**UNITED STATES  
NUCLEAR REGULATORY COMMISSION  
ADVISORY COMMITTEE ON REACTOR SAFEGUARDS  
WASHINGTON, DC 20555 – 0001**

SUBJECT: CERTIFICATION OF THE MINUTES OF THE MEETING OF THE  
SUBCOMMITTEE ON ABWR REGARDING COL APPLICATION  
OF SOUTH TEXAS PROJECT (STP) ON FEBRUARY 8, 2011

ADVISORY COMMITTEE ON REACTOR SAFEGUARDS  
MINUTES OF THE  
ACRS ADVANCED BOILING WATER REACTOR SUBCOMMITTEE MEETING  
FEBRUARY 8, 2011, ROCKVILLE, MD

The purpose of the meeting was to review Chapter 7 of the Safety Evaluation Report with no open items associated with the combined license application for South Texas project Units 3 and 4. Discussion also included selected ACRS action items resulting from prior ABWR Subcommittee meetings. The meeting transcripts are attached and contain a detailed description of each issue discussed during the meeting. The presentation slides and handouts used during the meeting are attached to the transcripts.

ABWR DCD Figure 7C-1 Implementation of Additional Diversity in SSLC to Mitigate Effects of CMF

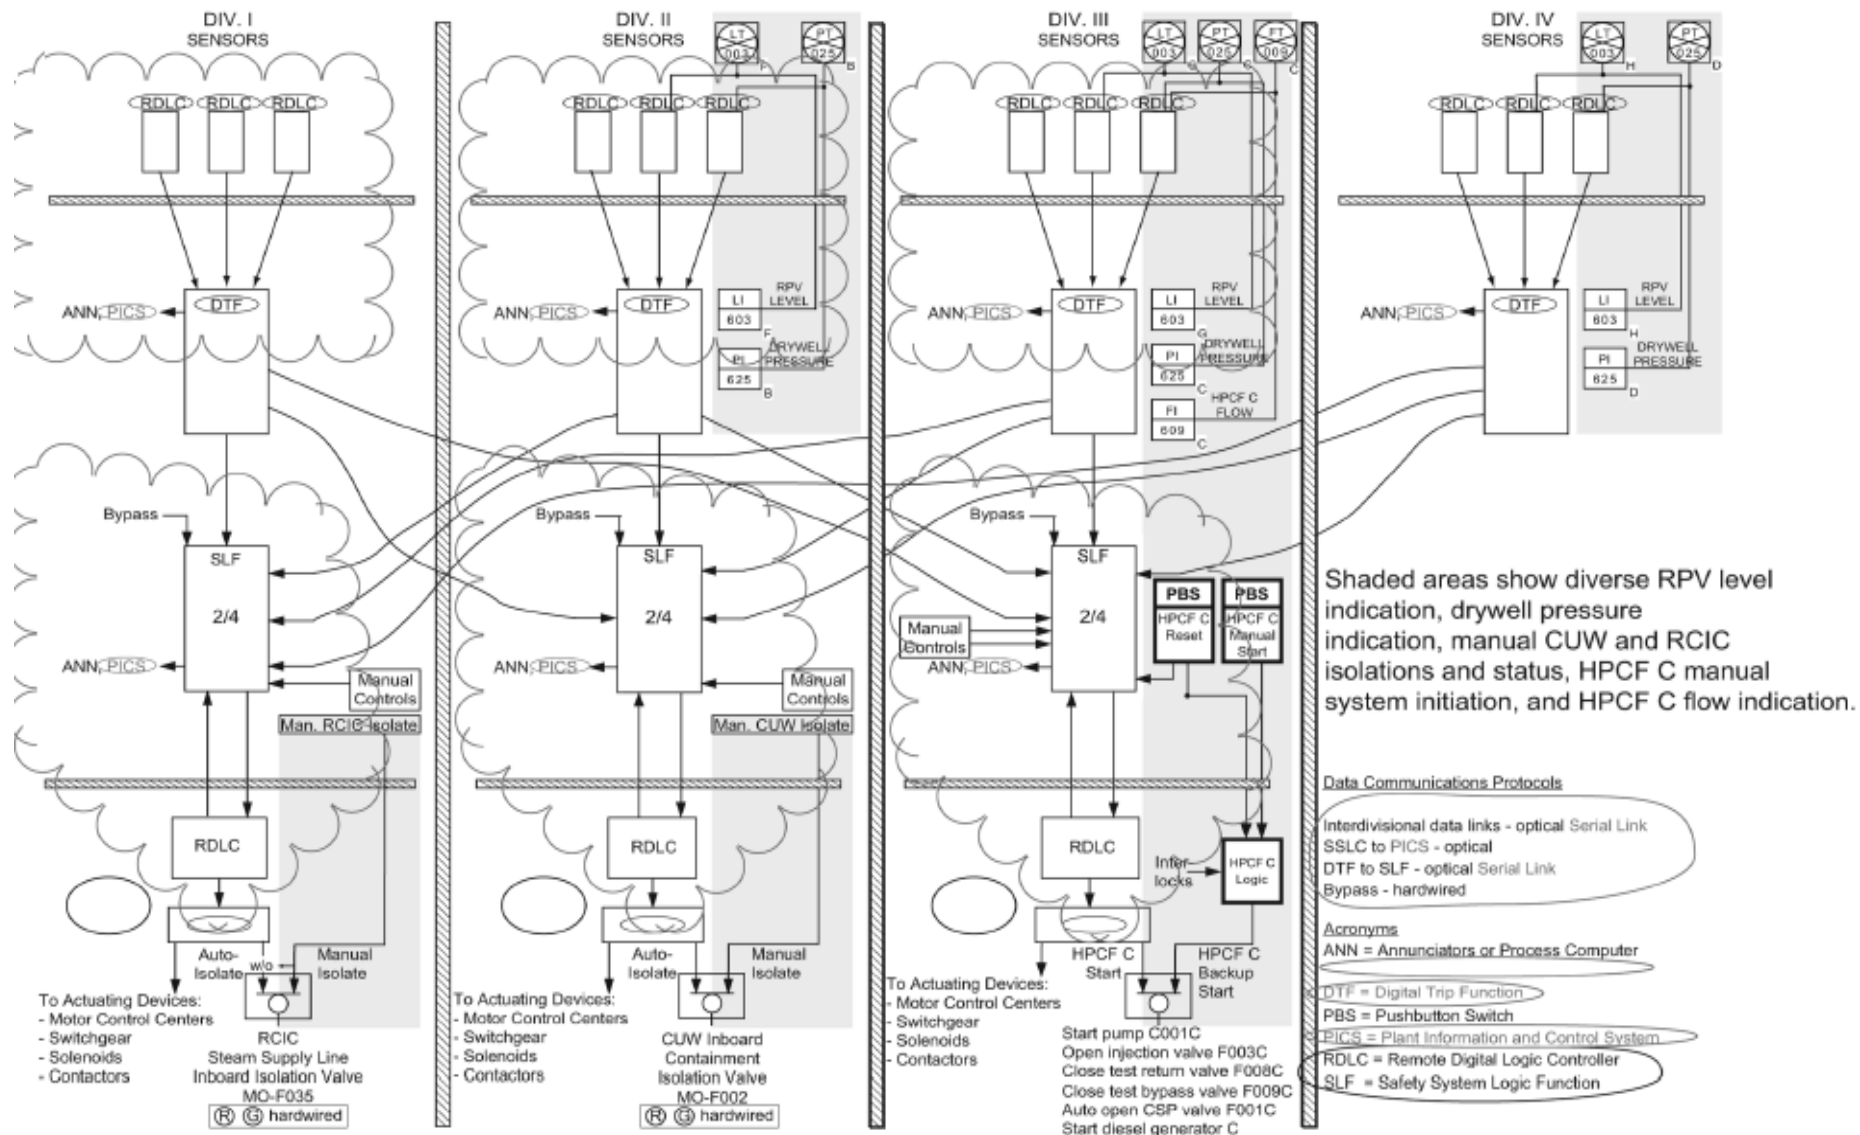
22 MEMBER BROWN: So there's a nuance. If I  
23 look at Figure 7C-1, where that -- in other words,  
24 there's a set of manual controls that go into the  
25 SLFs, and then there's another set of manual controls

3 CHAIRMAN ABDEL-KHALIK: Thank you. Before  
4 we take a break, I think we ought to capture the  
5 briefings that you need to clarify. Number one,  
6 you're going to go back and look at Figure 7C-1, 7C-1  
7 to try to answer John's question; is that correct?

4 MR. HEAD: We understand, okay. Thank  
5 you. So the first one I propose is to go back to  
6 Figure 7C-1, which we have on the board, excuse me,  
7 on the board, sorry.

18 The seven, Figure 7C-1, I believe  
19 we've just answered, and the 70 percent loading is  
20 a new one that we will carry and address in a  
21 future discussion. Okay. Maitri, is that --
